ADDENDUM No. 3 TO PROCUREMENT CONTRACT DOCUMENTS
BRIDGEPORT PUBLIC UTILITY DISTRICT (BPUD)

Arsenic Removal Project – Arsenic Removal System Procurement Contract

May 17, 2017

Bridgeport Public Utility District – Arsenic Removal Project

DEMOLITION PLAN

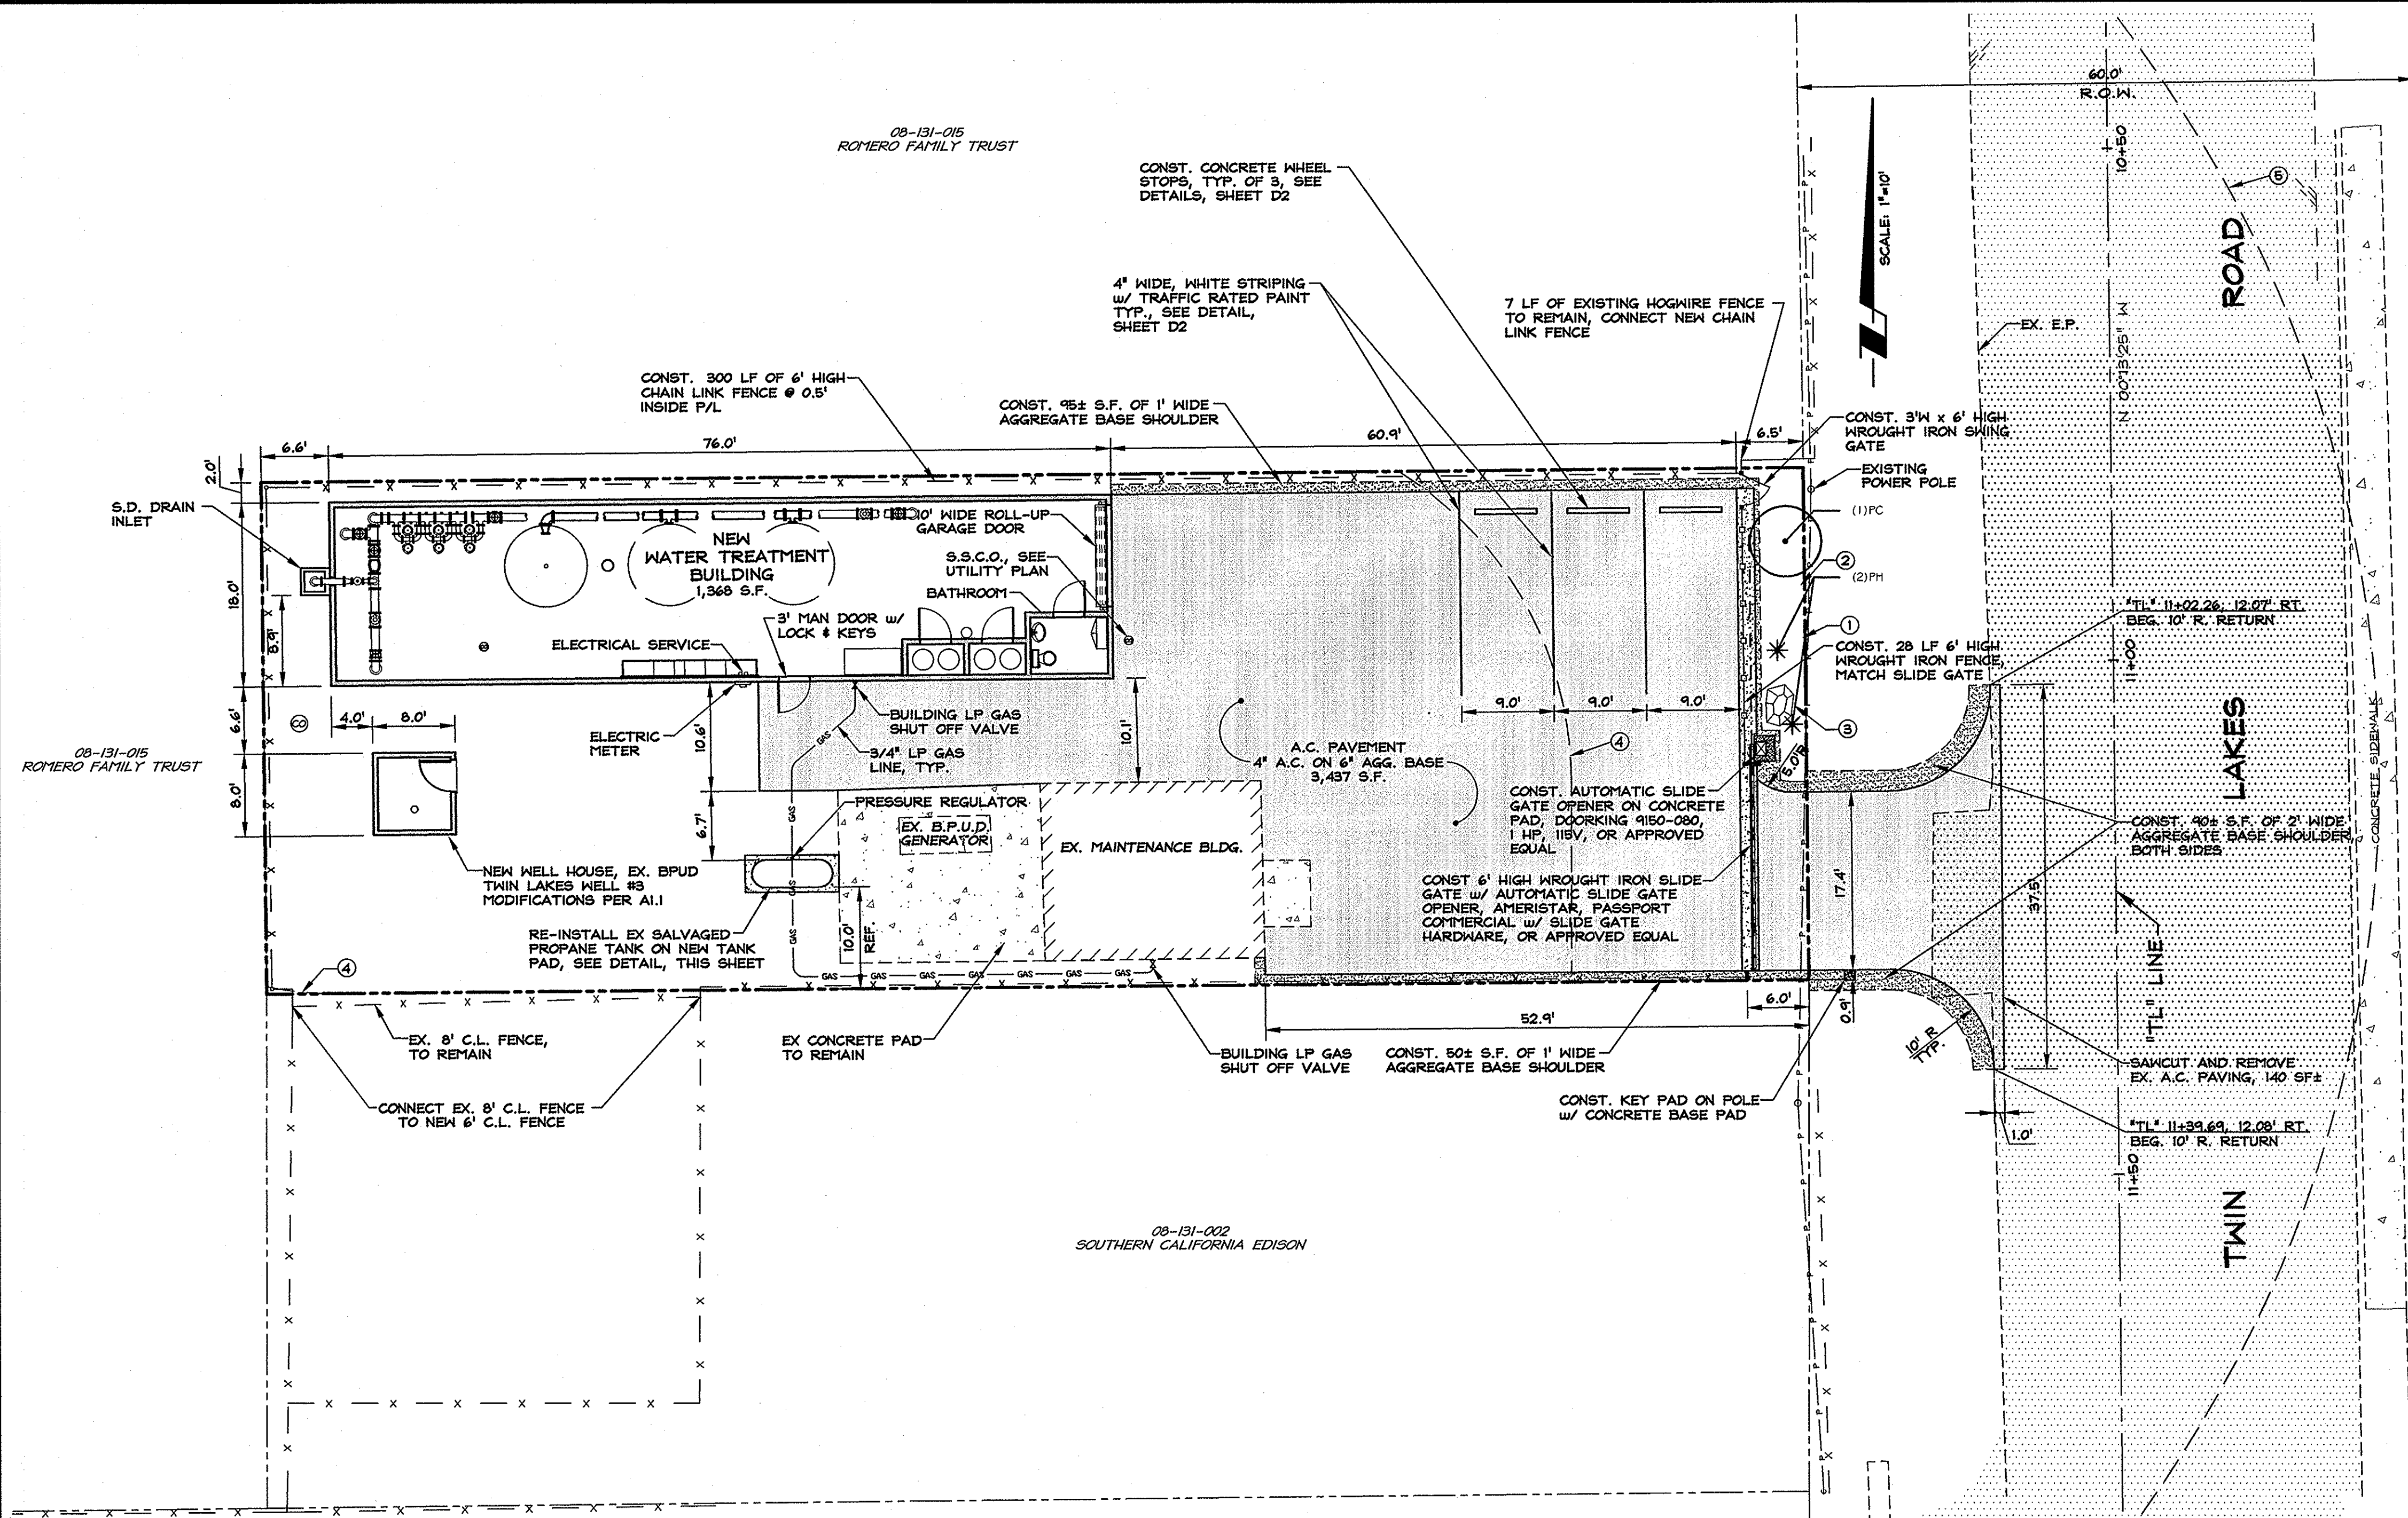
1. Note pointing to existing well house now reads: "Remove Ex Well House, Ref Sheet C7 for Piping Modifications".

**SITE / LANDSCAPE
 PLAN**

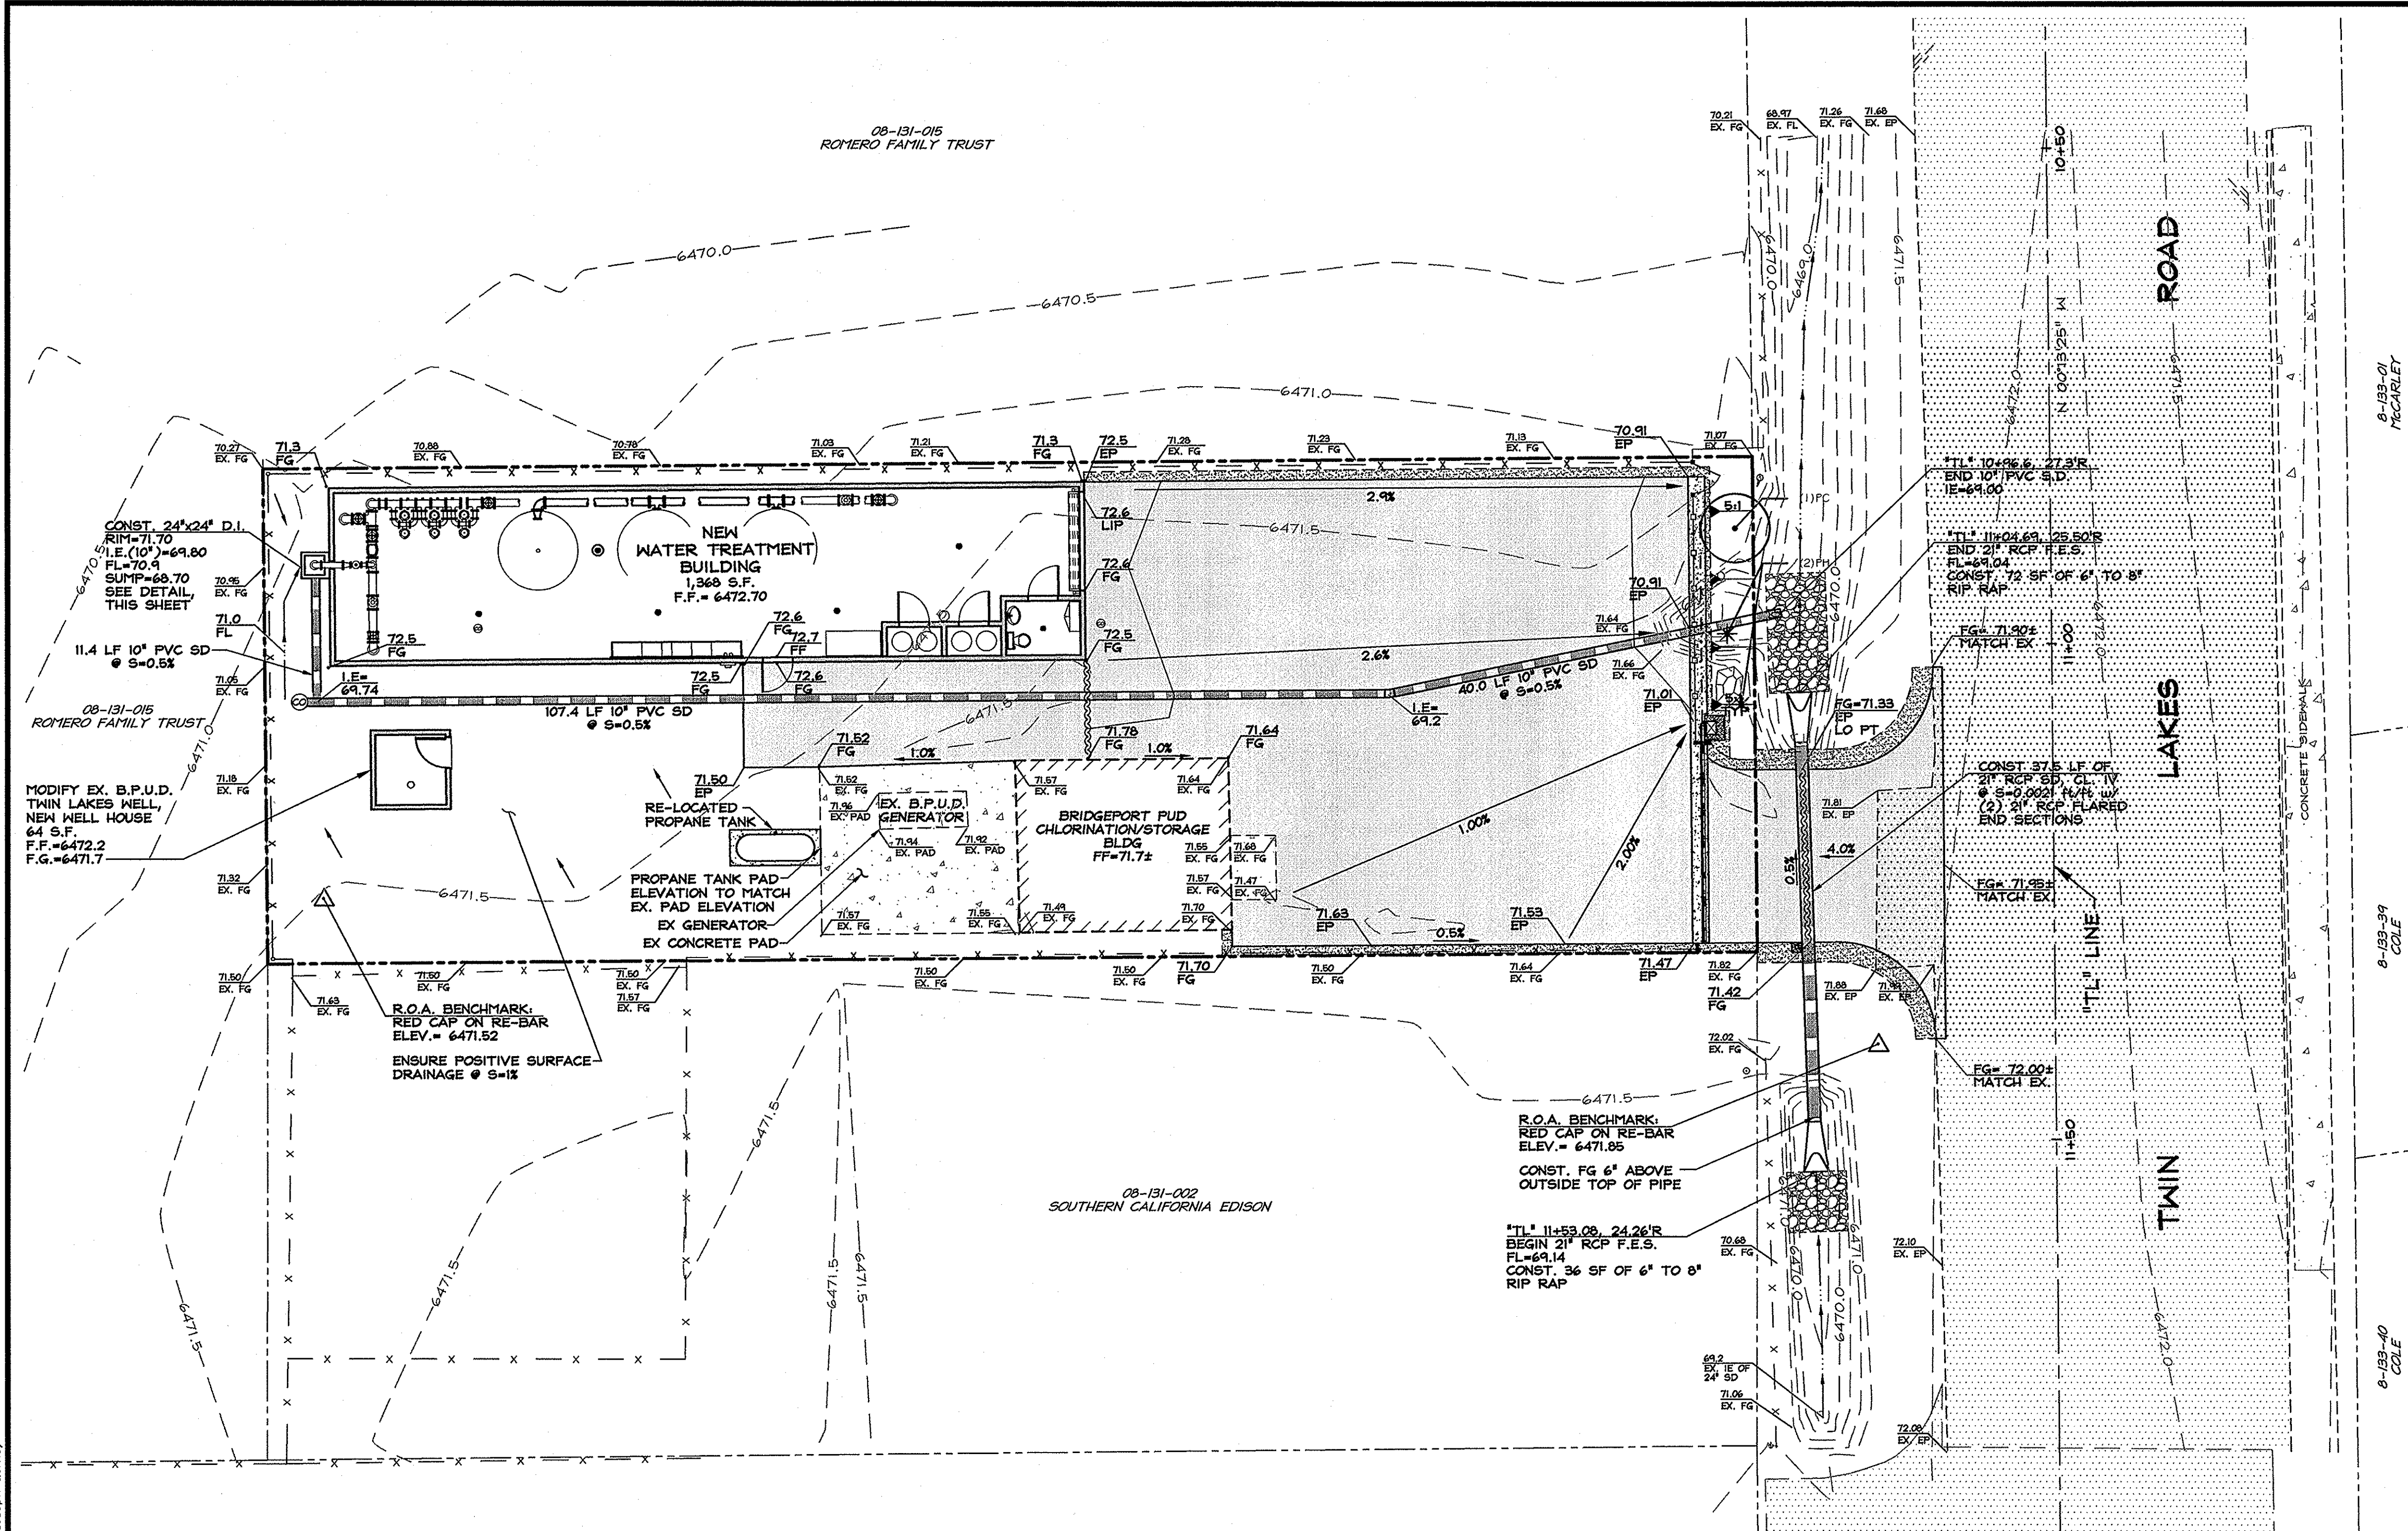
1. Correction to Landscape Notes #1, now reads: "Top Dress Landscape Area **and Disturbed Slopes** with 3'-8" Native Cobble". This was specifically changed to address the area to the north of the new treatment building.

GRADING PLAN

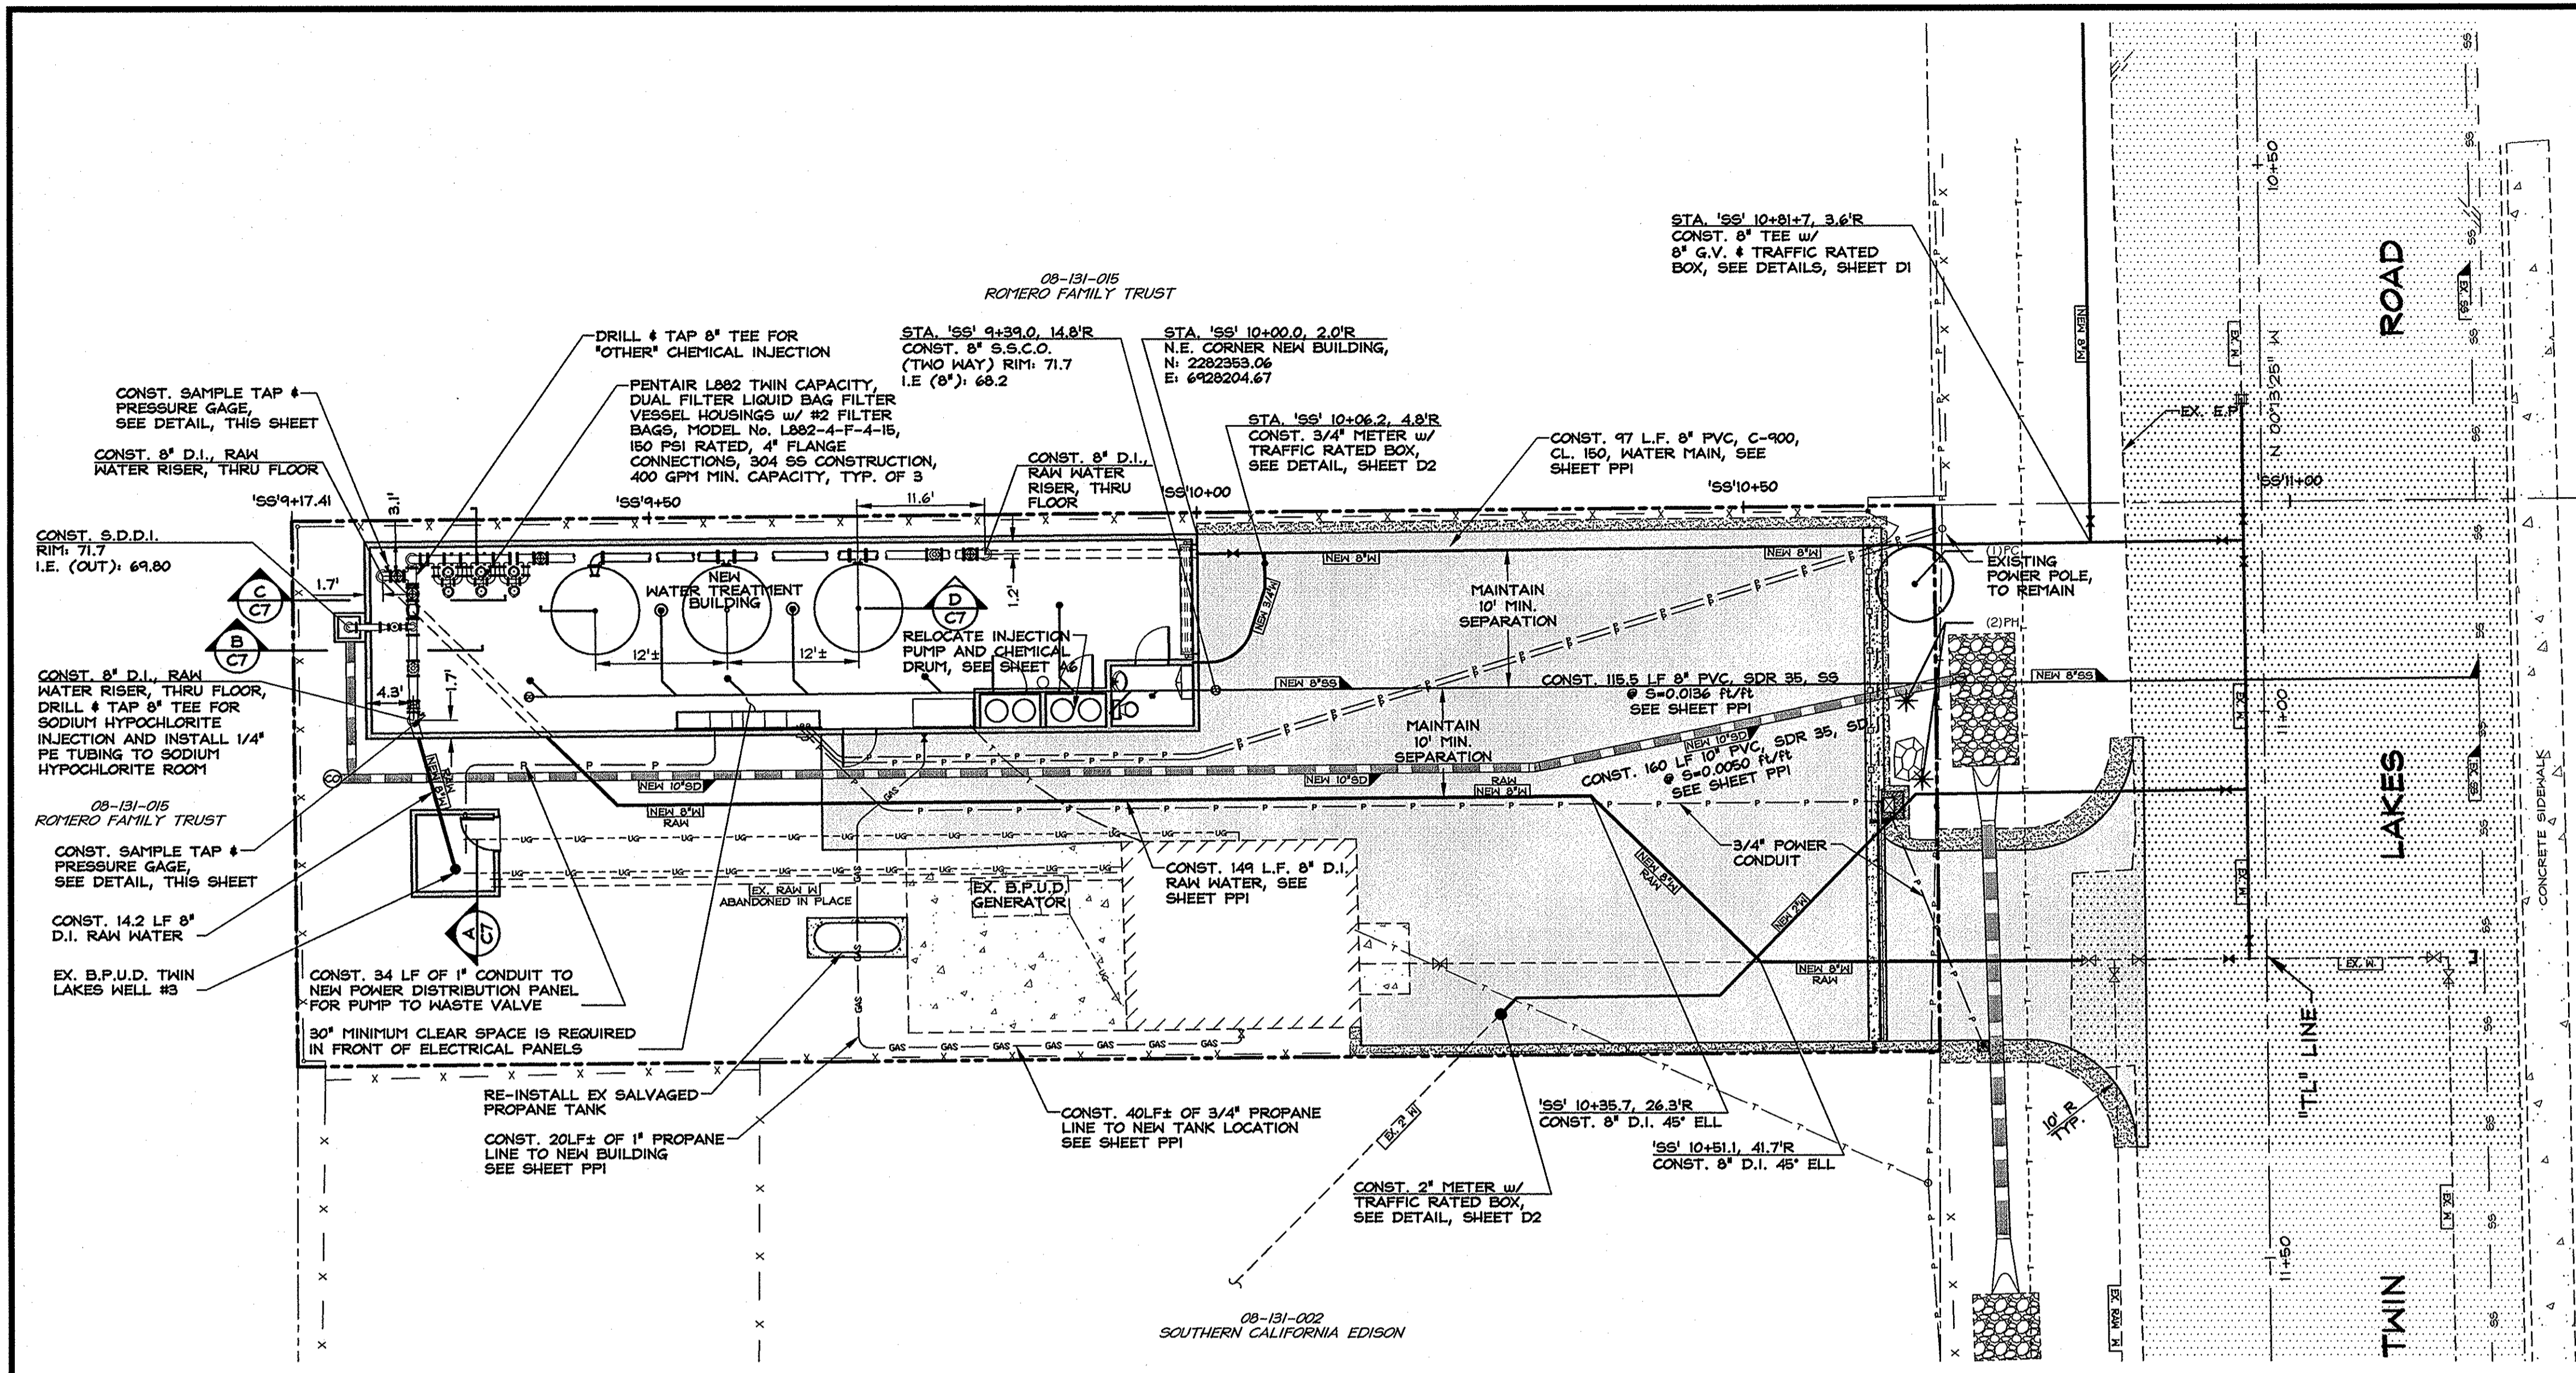
1. Addition to the 21" Storm Drain/Driveway Crossing Detail: Addition of Slurry Backfill below the Concrete Cap.
2. Addition to the 21" Storm Drain/Driveway Crossing Detail: Addition of reinforcing steel.
3. Addition of clean-out to the 10" PVC Storm Drain line.
4. Deletion of drainage swale around the Twin Lakes Well House in favor of Positive Surface Drainage as sheet flow @ S=1%.
5. Lowering of the Finished Grade surface on the northern side of the building affecting the foundation depth on that wall and on the north end of the west wall.

6. Correction to the Finished Floor Elevation of the New Water Treatment Building, now reads 6472.70.
7. Correction to the Edge of Pavement elevation at the north-east corner of the new treatment building, now reads 72.5.
